Staff Report

To: BOZAR
From: Jessie Earley, Senior Planner
Meeting Date: DRC, February 17, 2026
RE: Hass/Daalder (414 Maroon Avenue), Primary Review

PROJECT TITLE: Hass/Daalder (414 Maroon Avenue)

SUMMARY: Consideration of the application of **Emily E. Hass and Hermen Daalder** to site additions to the existing accessory building located at 414 Maroon Avenue, Lots 9 and 10 and the North half of Lot 11, Block 23 in the R1C zone.

2/17/2026 DRC: 3D renderings

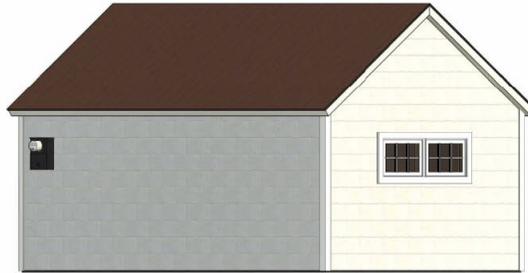
The Board will need to determine whether the additions will appear congruent or dissimilar with the surrounding neighborhood context per GL 4.26.

GL	Staff Analysis	DRC Recommendation
4.25 Excessive similarity	No conflict.	
4.26 Excessive dissimilarity	<p>Discussion is encouraged to determine if the proposed additions are acceptable or if they will appear excessively dissimilar.</p> <p>Staff encourages discussion about the materials as proposed for the addition to the existing accessory building as they do not properly cleave the difference between the existing historic structure and new addition.</p> <p>Staff finds that the windows proposed in the gables of the existing historic portion of the building on the west and east are not appropriate.</p> <p>Staff finds that the rehabilitation plan</p>

<p>may not be consistent with National Park Service standards and should be walked through to ensure that all historic materials will remain.</p>	
--	---	--

1 Existing Site Survey
 1" = 10'-0"

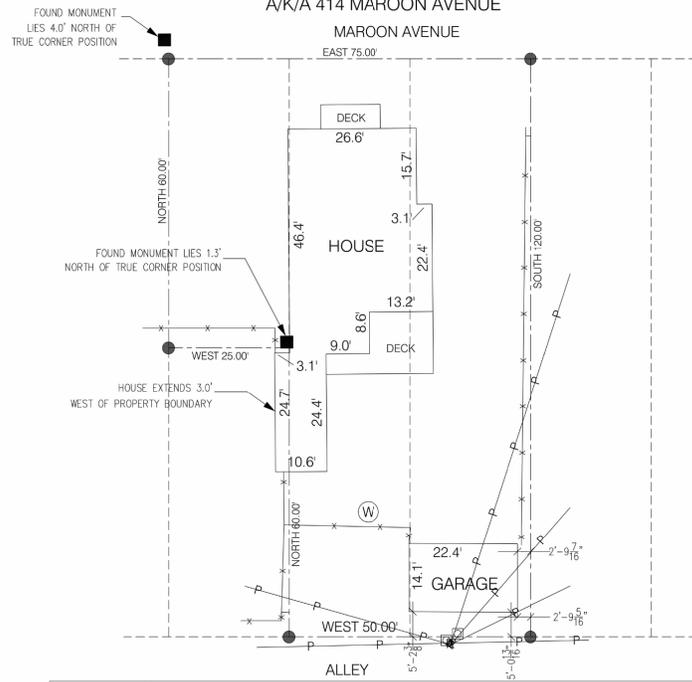
GL	Staff Analysis	DRC Recommendation
Topography	Topography is not included, but should be. This information is not anticipated to impact FAR or height requirement.

2.8 Drainage	Drainage arrows have not been shown but should be.	
Easements	None noted	
2.16 Substantial landscaping	The plan is fairly minimal. Provision of a final landscape plan will be required if there are revisions after permitting.

2.18/3.1 Preservation of existing mature trees	No trees are noted on the existing site plan. It will be important to note existing versus proposed trees on the site.

2.19 New trees	There is a tree shown on the northeast corner of the lot.	
2.16 a./ 2.20 Native plantings	Ground cover for disturbed areas has been noted as grass. Native plantings are encouraged by the GL.

(2.37-2.40)/ 16-17-40 Exterior Lighting	Existing and proposed lighting has been included. They appear to meet the intents of the requirements. If existing fixtures do not meet requirements, they will be required to be upgraded as part of the work to be done.	
Solar	NA	
Utilities	Existing and proposed wet and dry utilities must be noted on the plan. The water line is noted from the alley. Rights of way (alley and Maroon Avenue) must be shown to scale on the site plans.

2.7 Snow Storage	Snow storage has been depicted on the plan and corresponds to the areas to be

plowed.	
2.27 Fences	An existing fence is on the east and west. Confirmation is needed if there will be a new fence proposed.

Plan view - proposed

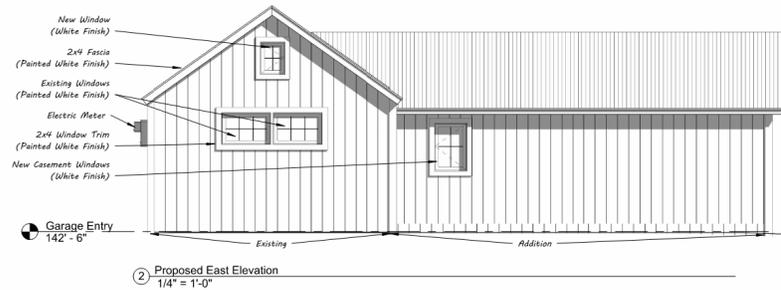
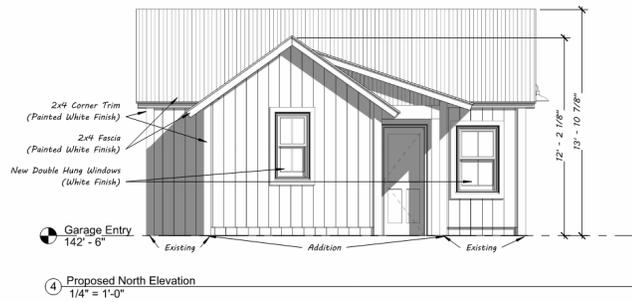
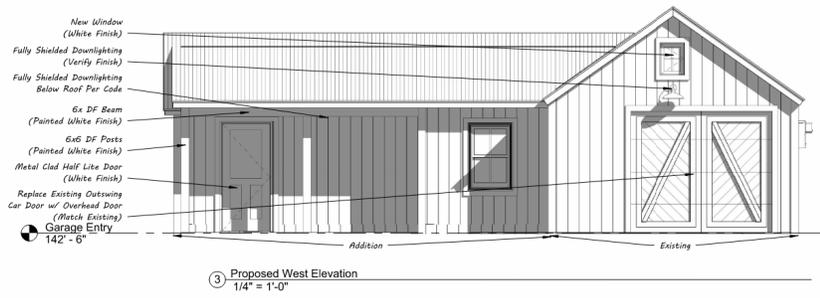
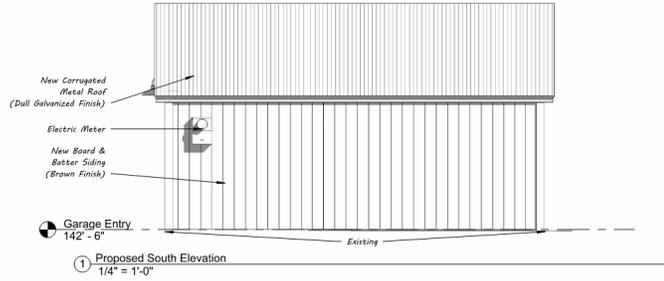
GL	Staff Analysis	DRC Recommendation
3.17 Additions to historic buildings	Accessory: The addition to the accessory building steps down from the main ridge and also from the east and west sides of the building, which is encouraged.	
3.18 a Stepping down additions	Accessory: The addition on the north steps down 1'8" from the main ridge. Discussion is encouraged to determine if the addition is subordinate.

3.18 b/ 3.36 Connector	This GL suggests a connector. This is a smaller building. The Board can discuss if this is necessary.	
3.18 c Mass	<p>Accessory: The existing AB is 226 sf and the addition is 362 sf, which is larger in size.</p> <p>Discussion is encouraged to determine if the addition appears large in comparison with the existing structure and other structures in the surrounding RIC zone district and if the proposed plans match scale of the surrounding buildings within the zone.</p>	
3.19/ 3.37 Additions as products of their own time	Accessory: The addition to the existing AB is proposed to match. The additions should have siding proposed that should be distinguishable from the existing historic building.	
3.21 Traditional entrance pattern	The existing person door on the east will be removed, but again this was a later addition to the building.

③ Proposed West Elevation
1/4" = 1'-0"

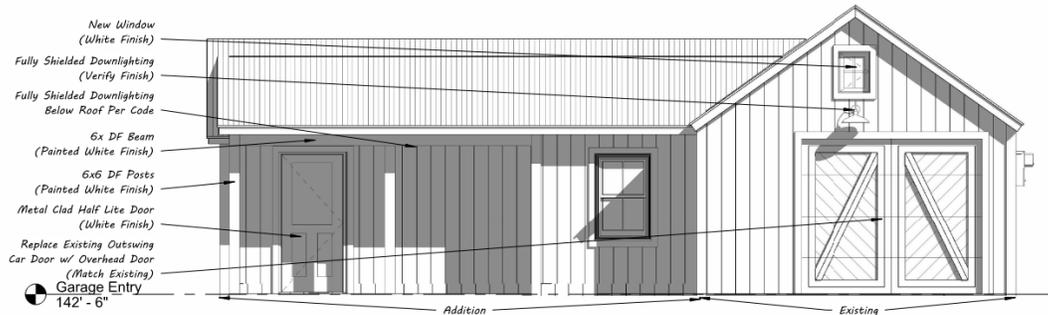
GL	Staff Analysis	DRC Recommendation
4.89 d. porches	There is a shed porch on the northwest side of the addition.

GL	Staff Analysis	DRC Recommendation
4.53; 4.89 AB fenestration	<p>The existing east elevation has a window. This window will be evaluated.</p> <p>Also on the east, there is a window proposed on the gable and a double hung on the new addition.</p> <p>There is a window proposed in the gable on the west portion of the existing building and also a double</p>	Support

GL	Staff Analysis	DRC Recommendation
4.66 Secondary Doors	<p>There is an existing person door that is proposed to be removed.</p> <p>Then there are two half light clad doors proposed on the west and north elevations of the addition.</p>	
4.69, 4.90 Garage doors	<p>There is an existing outswing wood garage door. This is proposed to be a replacement overhead door.</p> <p>It would be asked for this material to be used on the outside of the new door.</p>

④ Proposed North Elevation
1/4" = 1'-0"

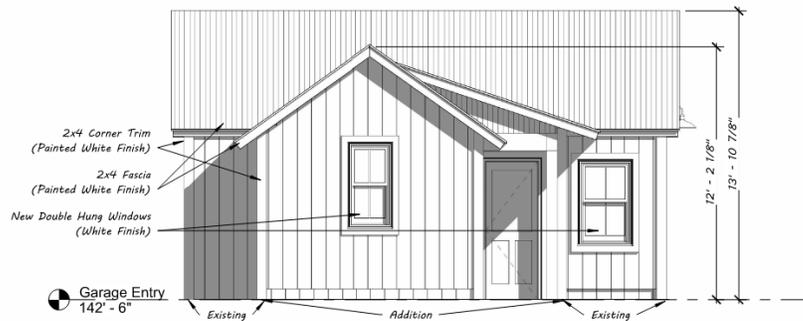
<p>hung for the new addition.</p> <p>The south elevation remains without windows.</p> <p>The north elevation proposes two double hung windows.</p>	
4.54 Vertical emphasis	Windows are proposed as two over two awnings with simulated divided lights.	
4.56 Window material	Windows are noted as fiberglass for the new addition.	
4.59 Trim	Wood trim 2"x4" (white) is noted. Support
